Comments, Questions & Concerns for 3 & 5 San Marcos Drive 1-3-5 San Marcos Drive

Thursday June 20, 2023
Thursday August 17, 2023
Revised for August 15, 2024

Three lot Subdivision with semi-attached dwellings Proposition

PROJECT	DESCRIPTION

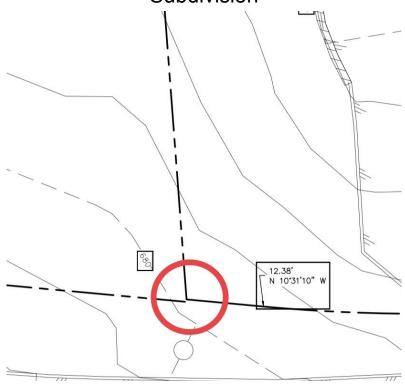
Improper Street name

Improper Address

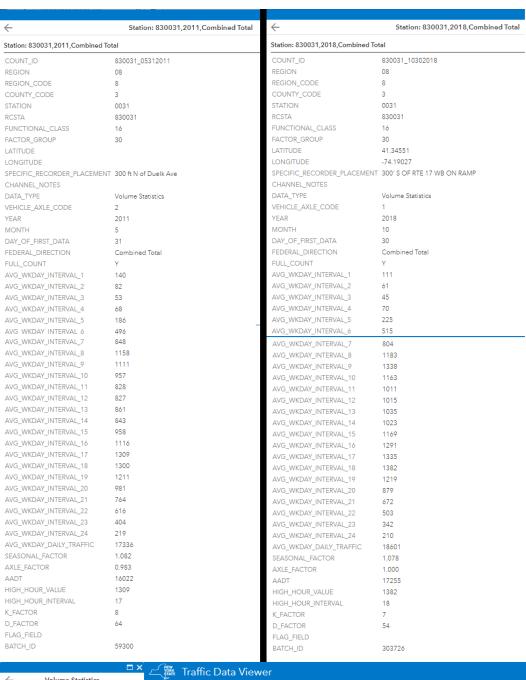
-	That same week, taxis can be heard as early as 8:30am, with a frequency of 3-5 visits to two or three houses. This includes one household who had (3) taxis from the time of 8:55am and 10:45am honking for someone to come out.
	NYS Traffic Data Viewer Looking at some data comparing 2011 to 2018, there is an increase of traffic
	Where is more recent data to compare it to?

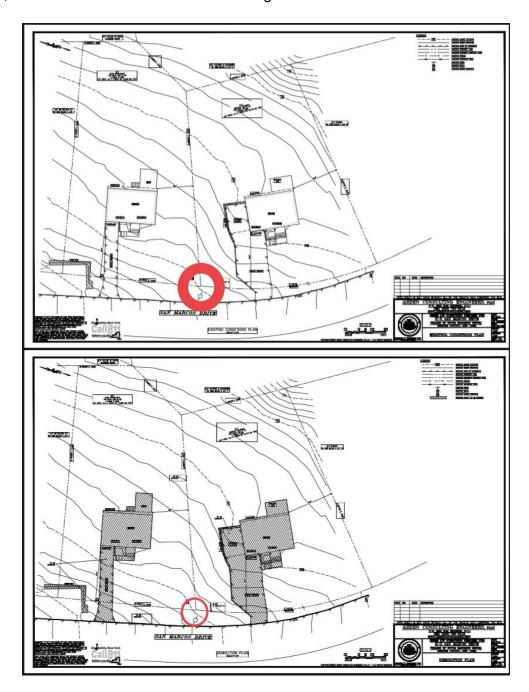
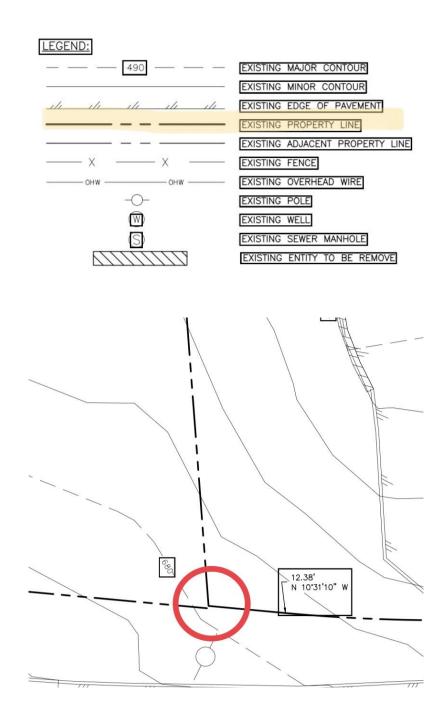
Can't find any articles online, checked Times Herald Record, The Photo News.

Where are the posters?
